Plan Commission  
Meeting of April 13, 2026  
Agenda #11, Legistar #91908

The letter of intent states: "The west side of the property will have a new 6'-0" wide bituminous path within a proposed 15'-0" wide storm sewer and path easement to connect the sidewalk along Helena Street to the city bike trail along the south side of Eastwood Avenue."

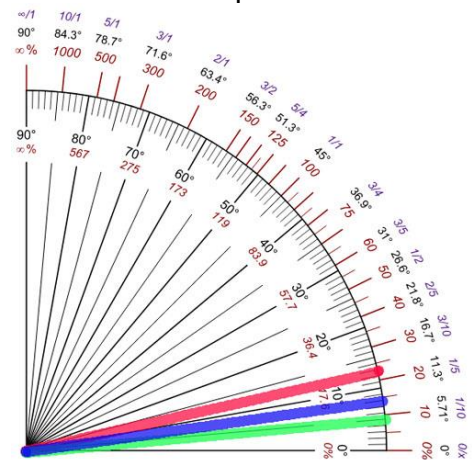
This connection would be through the public right-of-way with a relatively steep slope. As proposed, the path would drop 4 feet over a 30 foot length. This is a slope of 13.4%, per page 8 of the plans.

Although this proposed path is called a bike path in the staff report, it is really a shared use path (unless pedestrians would be prohibited). The proposed path would not be ADA compliant. While the slope would be 13.4%, ADA limits walking slopes to a maximum of 5%. Ramps are limited to a maximum slope of 8.33% (and handrails are required for the ramp).

This is a visual representation of the difference.

Red: the proposed slope  
Blue: ADA compliant ramp slope  
Green: ADA compliant sidewalk slope

The City should not permit this path through the public ROW to be created. It would not be ADA compliant, it would put the health of the remaining trees at risk, and there are nearby connectivity points.

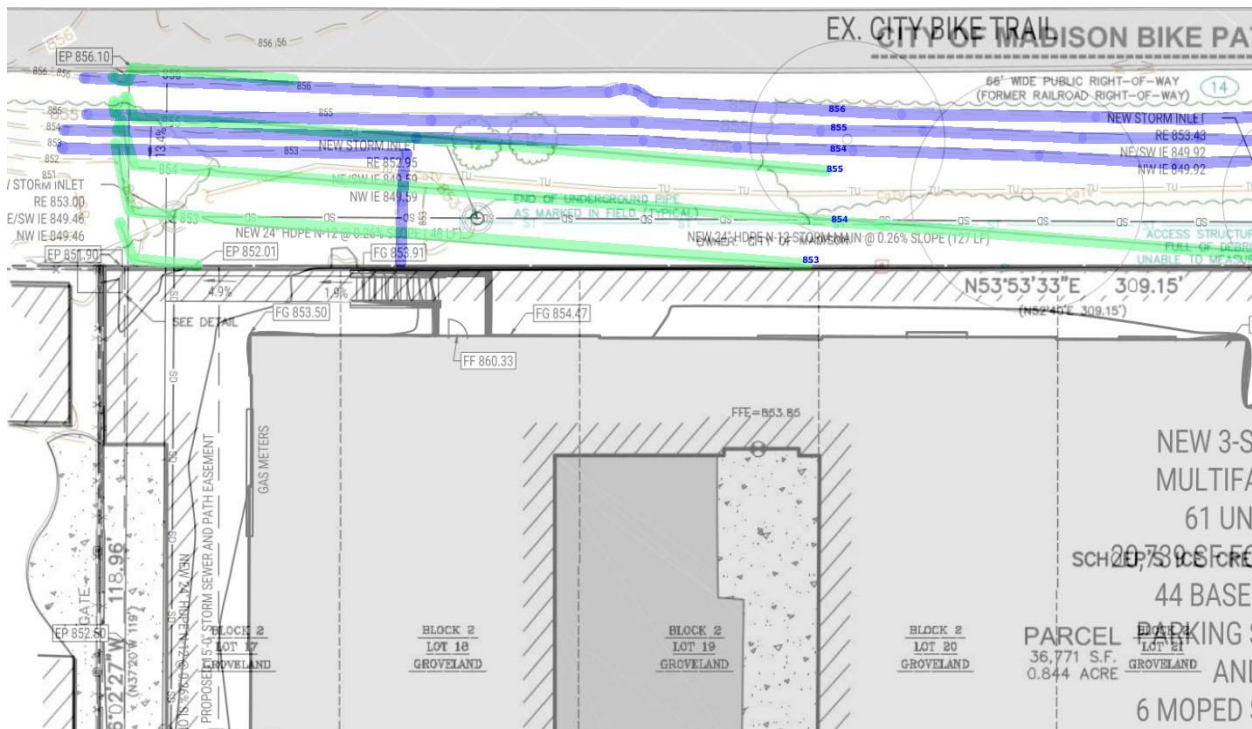
The applicant is removing many trees in the ROW - the plans show only 4 trees will remain. The tree report states that 3 of these trees, the larger trees, "will suffer" if the grade is changed.

Now proposed condition #48 reflects that Forestry will give permission to remove all the trees near the property line. If it were not for the grading, these 4 trees could remain.

The image below shows the extent in the change of grade. The purple is the existing grade, the green is the proposed regrading. For example, a 10 inch DBH Black Walnut will have about another foot of soil placed over the tree's central area, including the trunk.
